RESPONSE TO REQUEST FOR ADDITIONAL INFORMATION

APR1400 Design Certification

Docket No. 52-046

RAI No.: 269-8319
SRP Section: 09.02.02 - Reactor Auxiliary Cooling Water Systems
Application Section: Section 9.2.7
Date of RAI Issue: 10/22/2015

Figure 9.2.7-1 Essential Chilled Water System Flow Diagram (1 of 4)

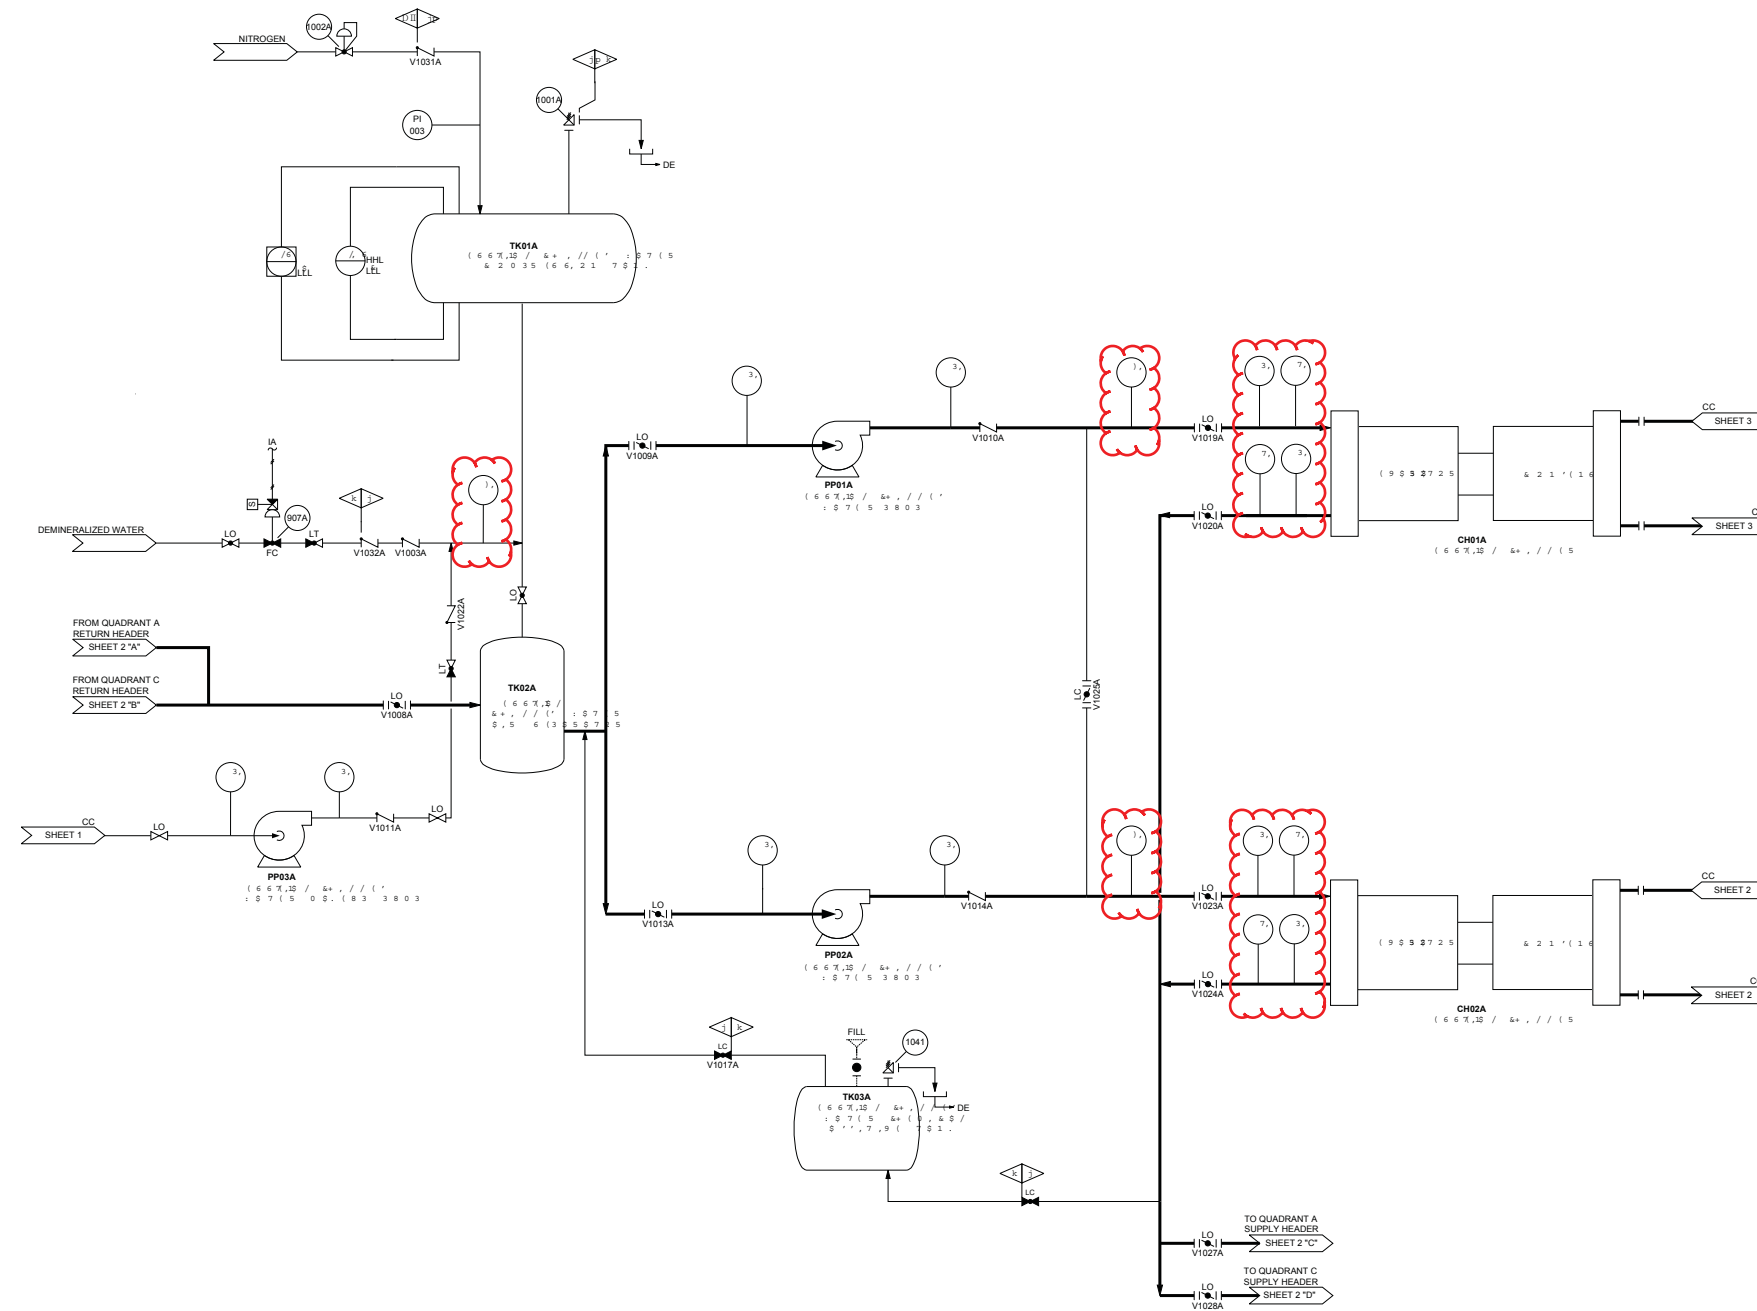
- a) DCD Tier 2, Section 9.2.7.5 states "local temperature and pressure indicators are provided at selected points in the system;" however, it is unclear to the staff if this information is included on Figure 9.2.7-1.
- b) DCD Tier 2, Section 9.2.7.5 specifies that inlet and outlet pressure of the evaporators are provided; however, this is not shown on Figure 9.2.7-1.
- c) DCD Tier 2, Section 9.2.7.5 provides a list of main control room (MCR) and remote shutdown room (RSR) indication and alarms; however, it is not clear to the staff what control instrumentation is available to the operators and which instruments provide the input to specific indication or alarms.
- d) DCD Tier 2, Section 9.2.7.5 or Figure 9.2.7-1 do not include instrumentation, controls, or alarms for protection against freezing, high/low refrigerant pressure, refrigerant leak detection, flow, and temperature.

The applicant is requested to address the above items regarding instrumentation and controls for the ECWS. DCD Tier 2, Section 9.2.7, Figure 9.2.7-1, and DCD Tier 1, including Table 2.7.2.3-3, should be revised accordingly.

- a) Local temperature, flow, and pressure indicators will be added to the figure 9.2.7-1.
- b) Inlet and outlet pressure indicators of the evaporators will be added to the figure 9.2.7-1.

APR1400 DCD Tier 2, Figure 9.2.7-1 will be revised as indicated in the Attachment.
